McKinleyville Community Services District McKinleyville BMX and Park Project

Bid Addendum #1

Date of Issue: 19 April 2024

BMX TRACK AND PARK DEVELOPMENT
MCKINLEYVILLE, CA
UTILITY PLAN

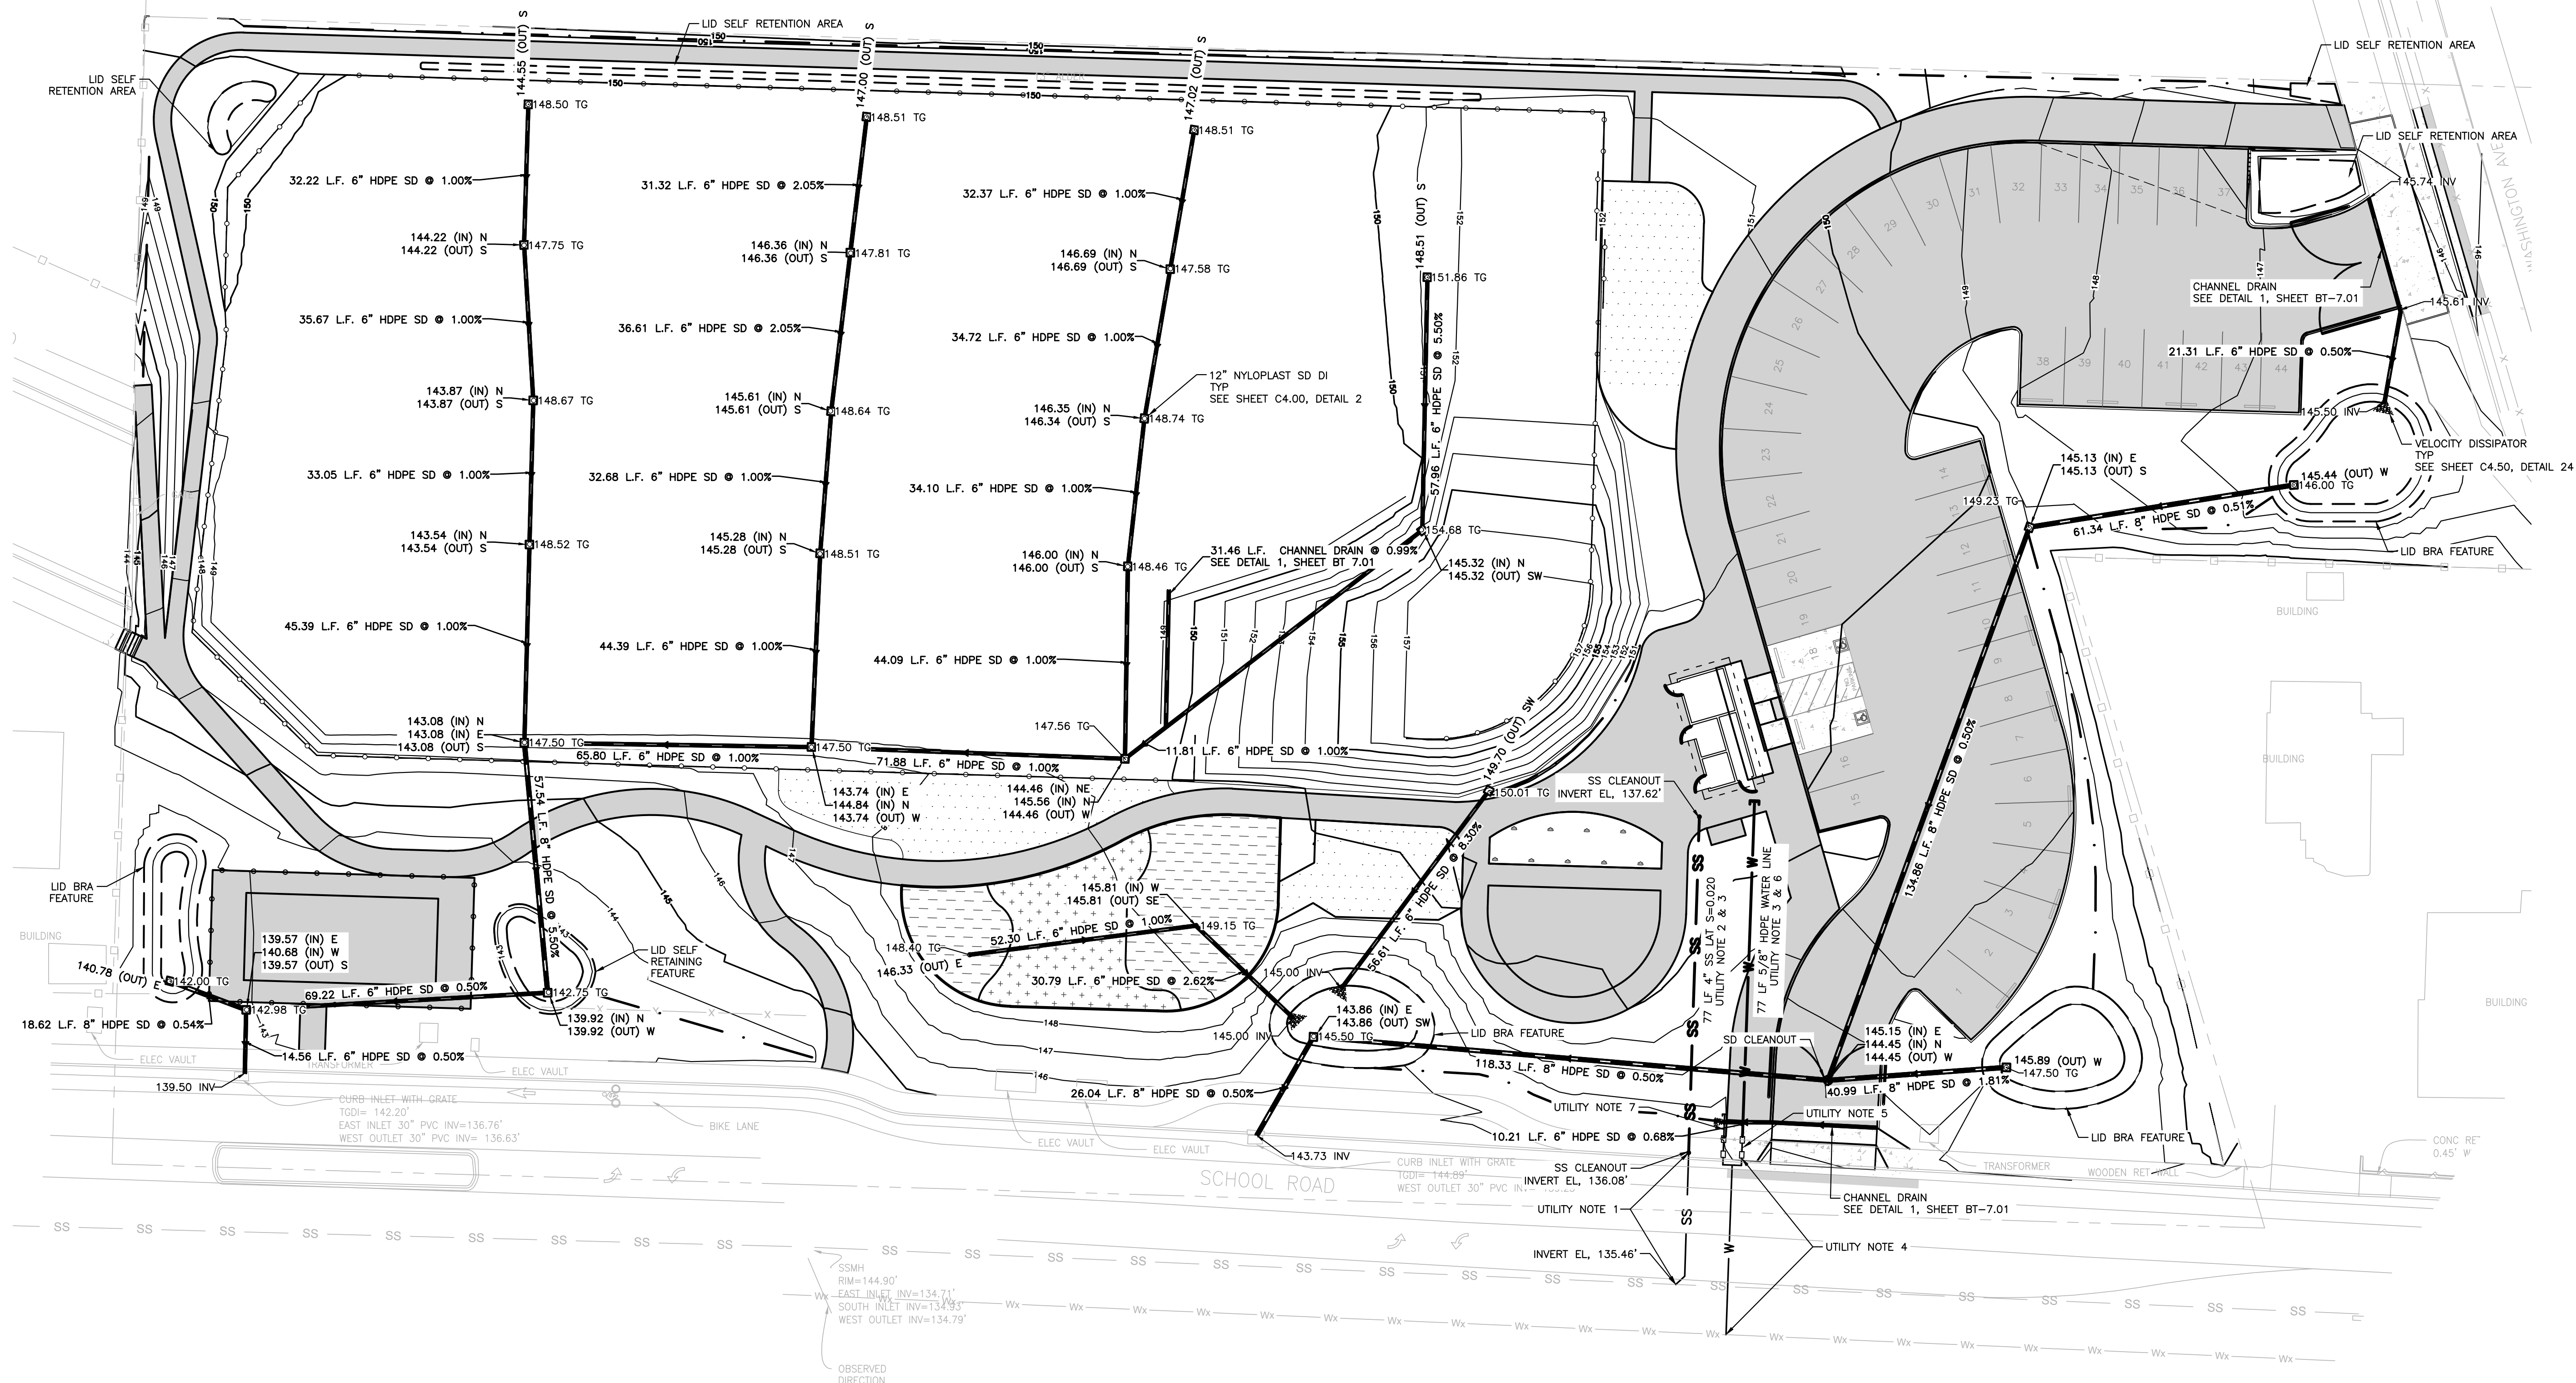
9. There's a unique call-out for the sewer service installation please explain.

Sheet C.3.00 - Utility Plan: Utility Notes have been edited.

- A. Utility Notes on Sheet C3.00 have been revised.
10. Is General Contractor responsible for a percentage of the track shaping?
A. No. The General contractor will be responsible for building a pad to the elevations shown on Sheet C2.00. The Track Shaper will then use that soil to shape the track.

- CONTRACTOR TO PURCHASE AND INSTALL NEW 4" SEWER SERVICE LATERAL ON MAIN, 4" LATERAL AND CLEANOUT TO BACK OF CURB PER MCSD STANDARDS SS-208 & 209.
- CONTRACTOR RESPONSIBLE FOR PROVIDING 4" SDR-35 FROM BACK OF SEWER CLEANOUT TO 5' OUTSIDE OF BUILDING. CLEANOUT AT BUILDING SHALL MEET MCSD STANDARD SS-209. COORDINATE WITH PLUMBER FOR ACTUAL TIE IN POINT OUTSIDE BUILDING.

**MATERIAL
REFERENCE
PLAN**

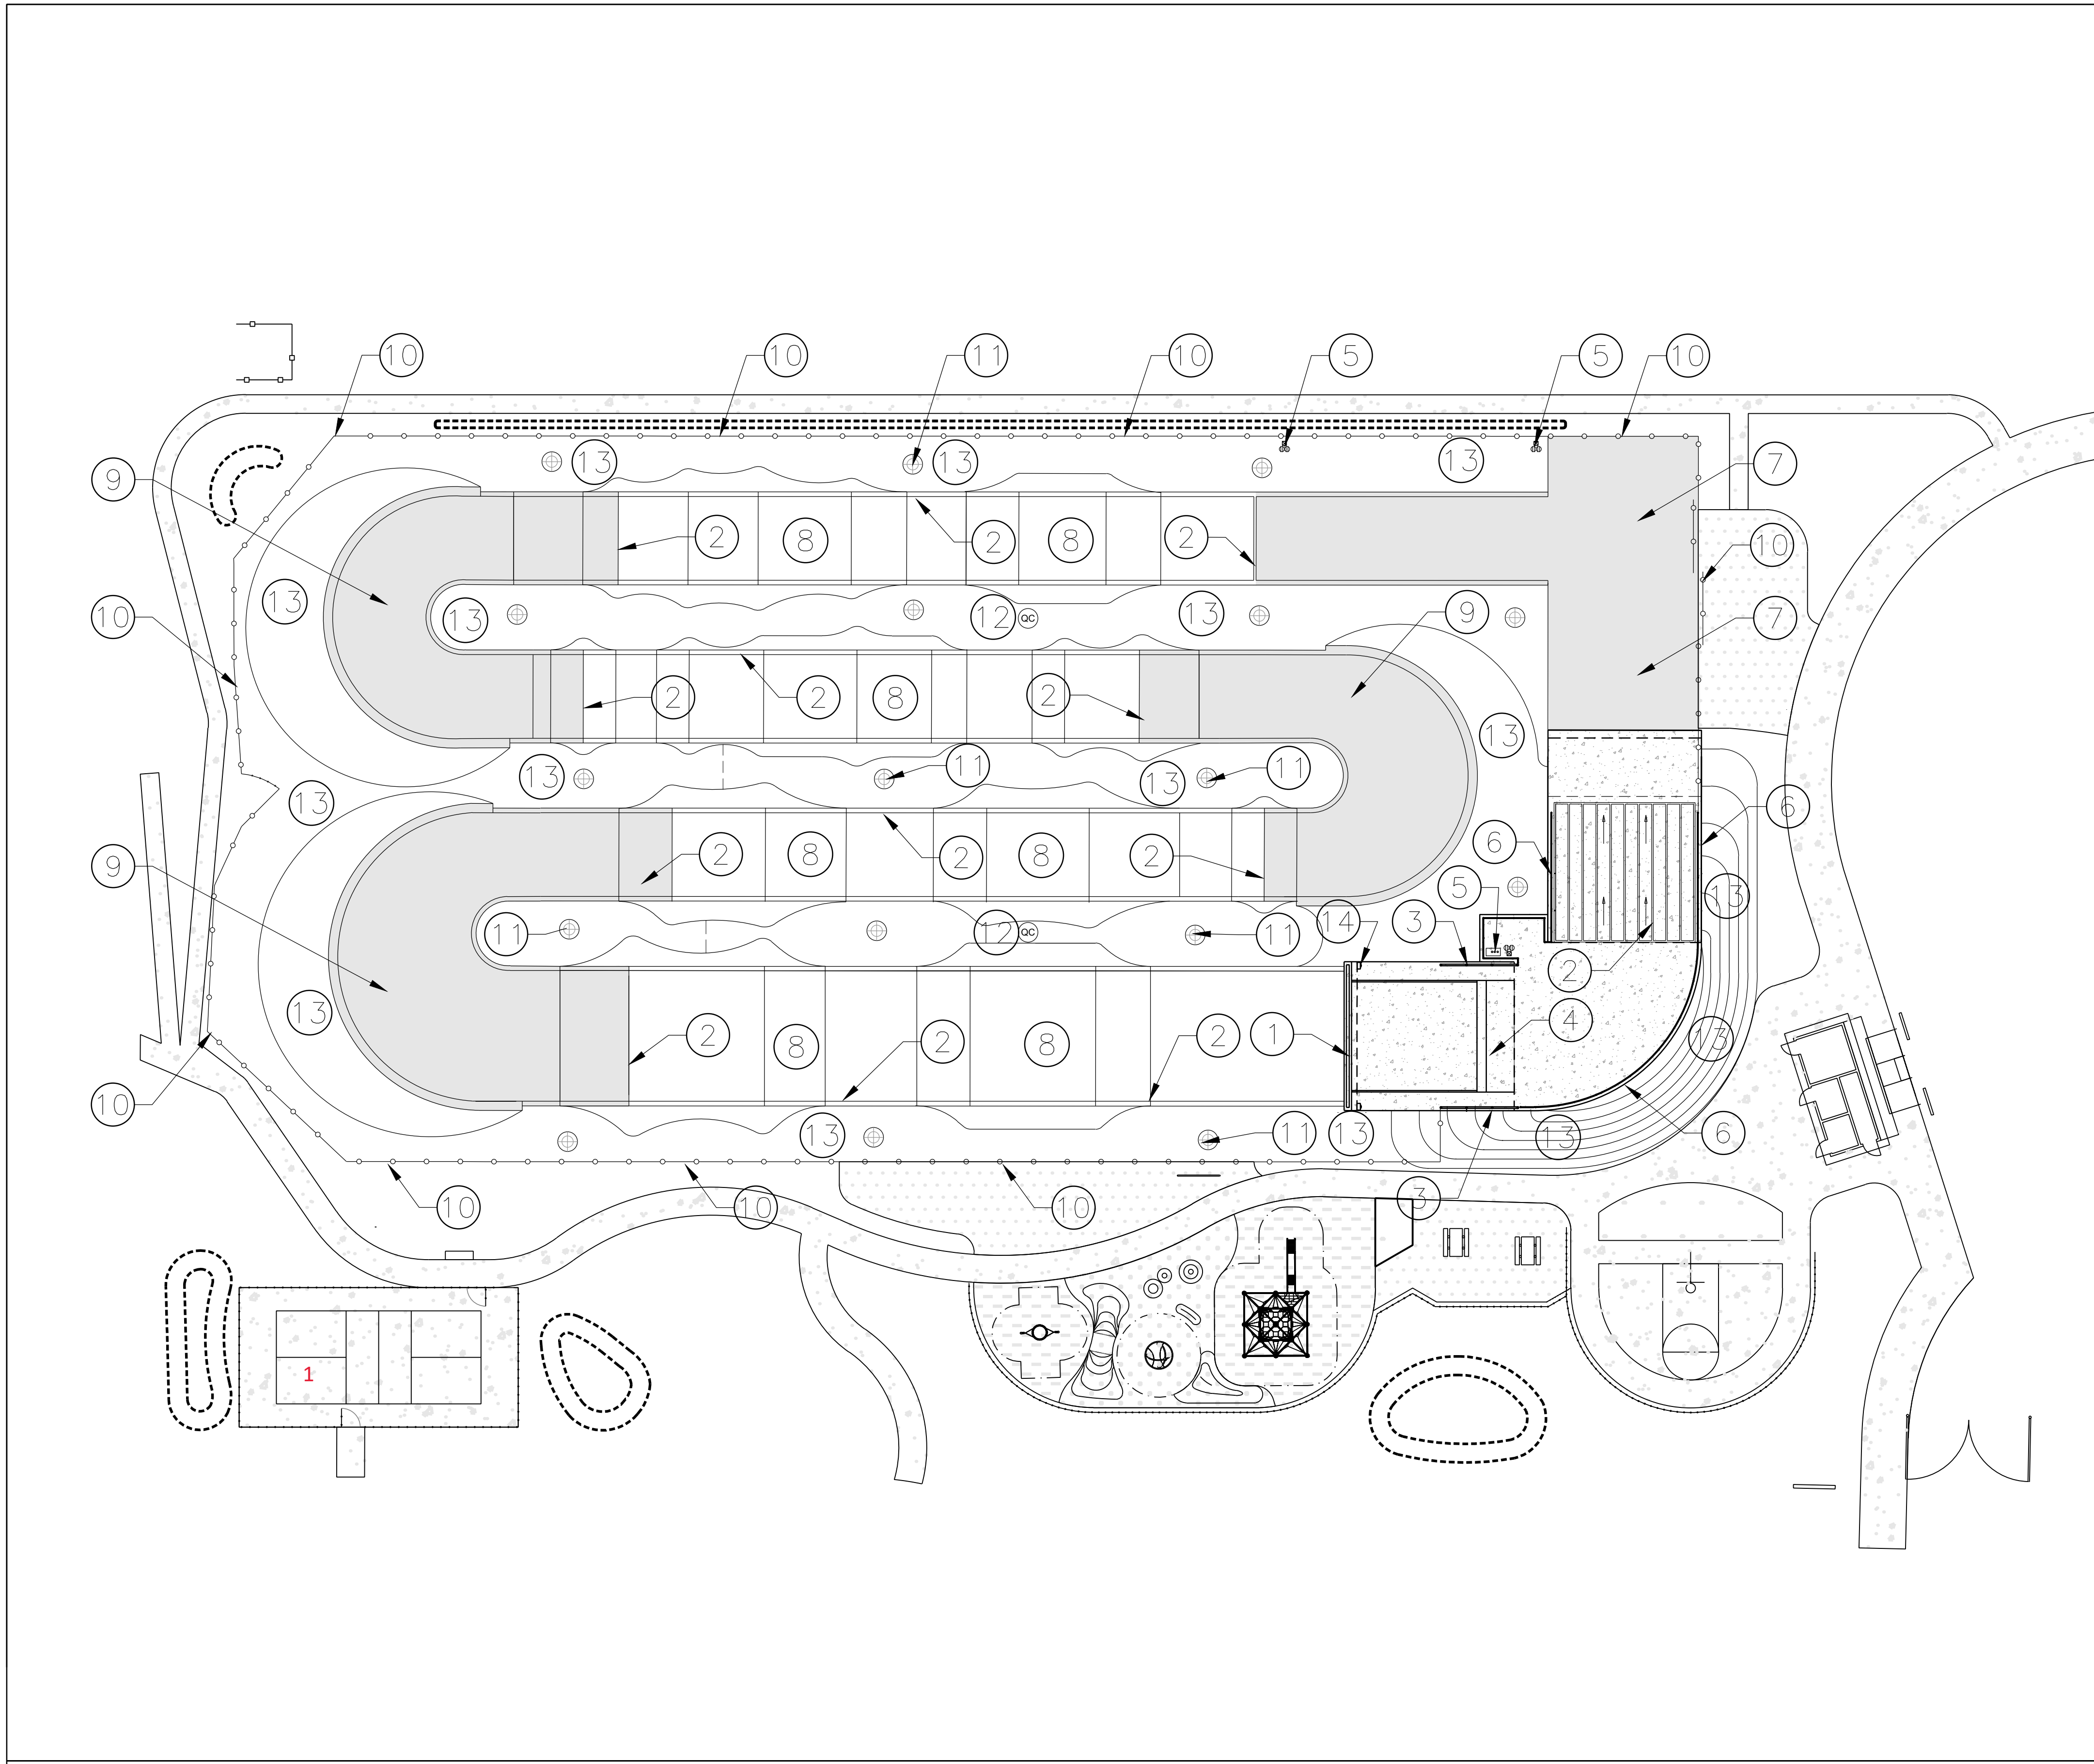
Sheet BT1.01 - Material Reference Plan: BMX Track Key Legend Item #9 has been edited.

- ⑧ TRACK CLAY SURFACE-SLURRY MIX
REFER TO DETAILS: 3-4-BT-7.01
- ⑨ ASPHALT BERM SURFACING-BID ALT 11
REFER TO DETAILS: 5-6-BT-7.01
- ⑩ BMX TRACK CONTRACTOR LIMIT OF WORK LINE.
GENERAL CONTRACTOR INSTALLED CHAIN LINK
FENCE LINE.

1 CHANNEL DRAIN @ START HILL BOTTOM SCALE N.T.S.

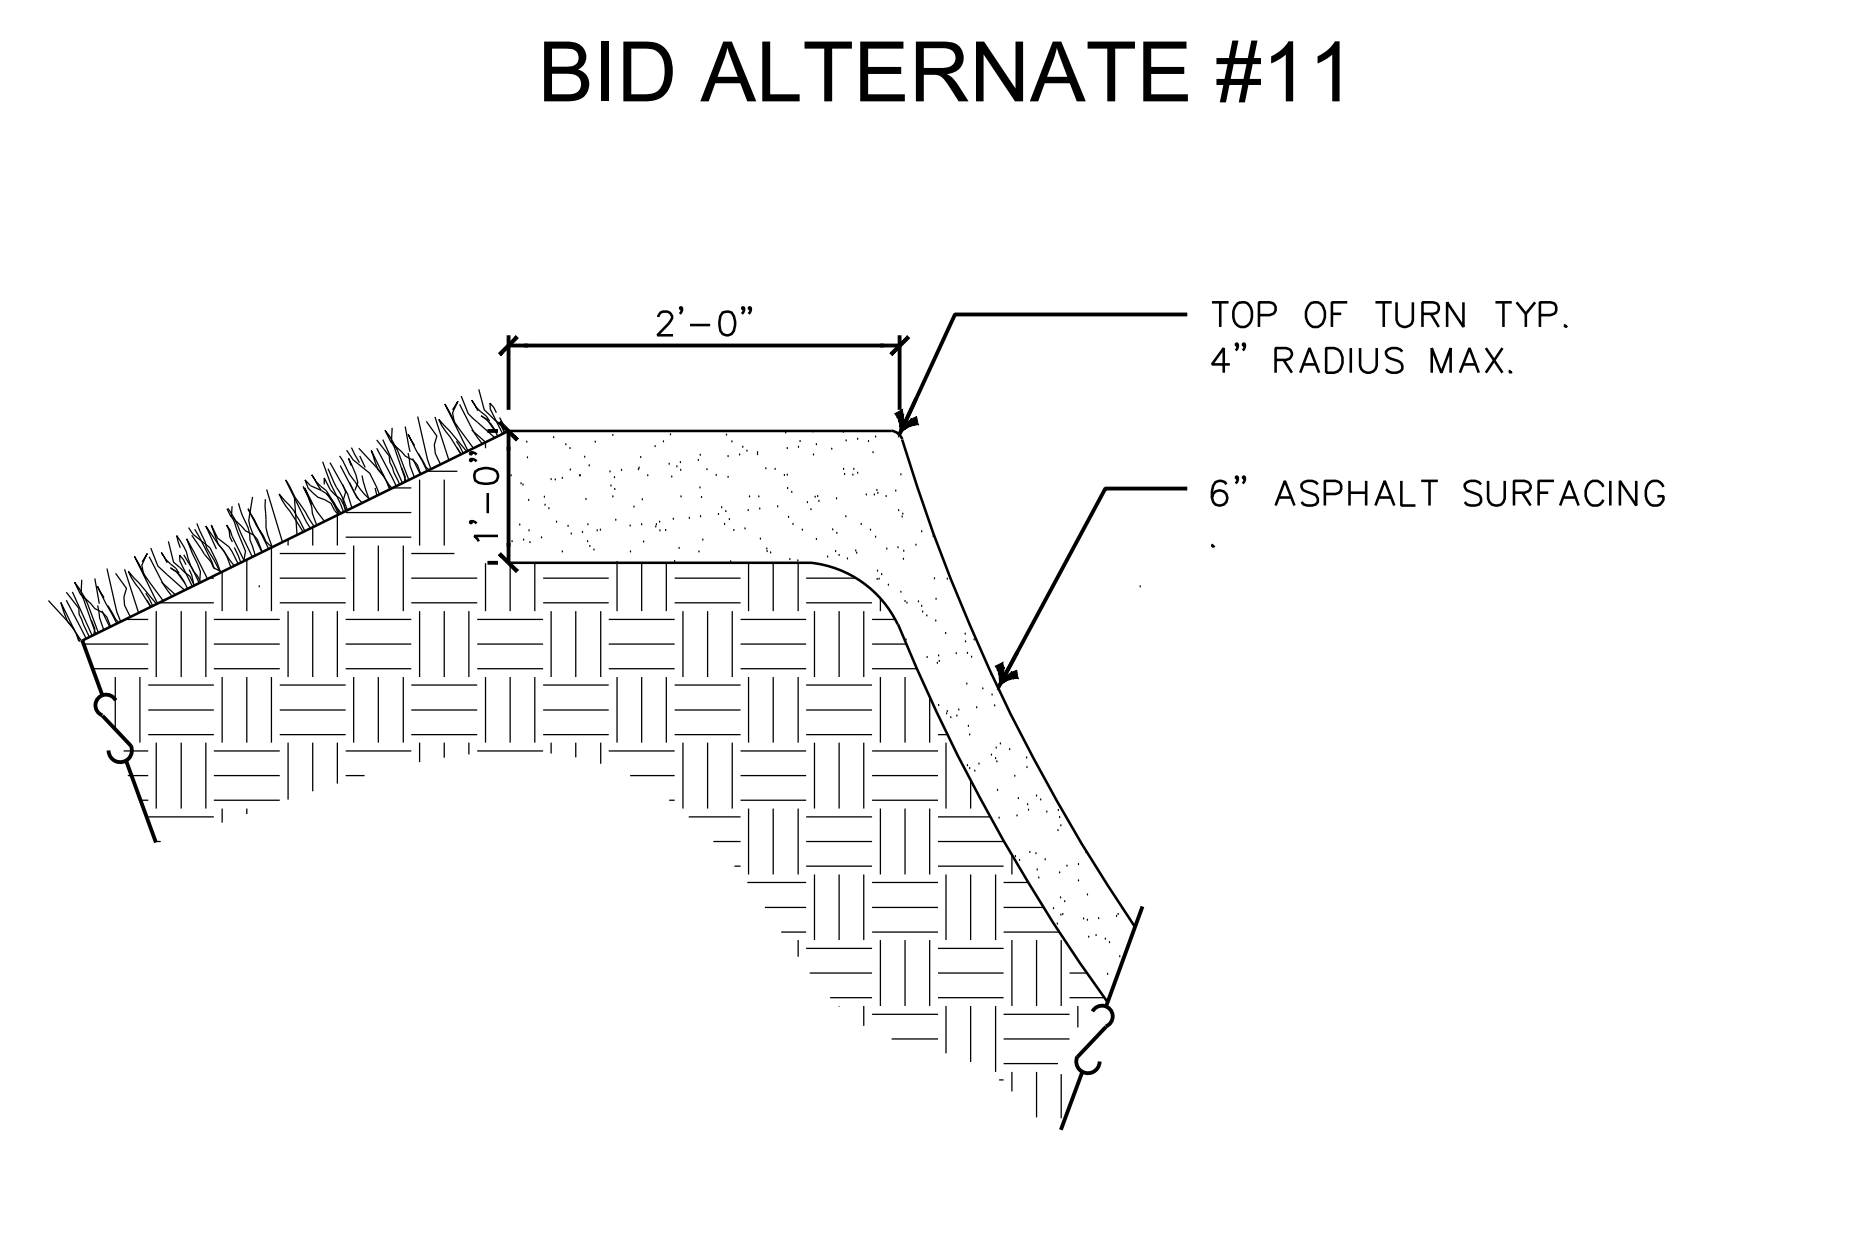
29. Item #13 Channel Drain. Bid quantity is 88 lf. Note on plan sheets C1.00 and C3.00 refer us to Detail 1 on sheet BT- 7.01. Is the detail relevant to all three locations? Is the 88 lf accurate for all?

RESPONSE: Yes, the referenced detail and bid quantity apply to all three locations. Channel Drain referenced C2.00, not C1.00.
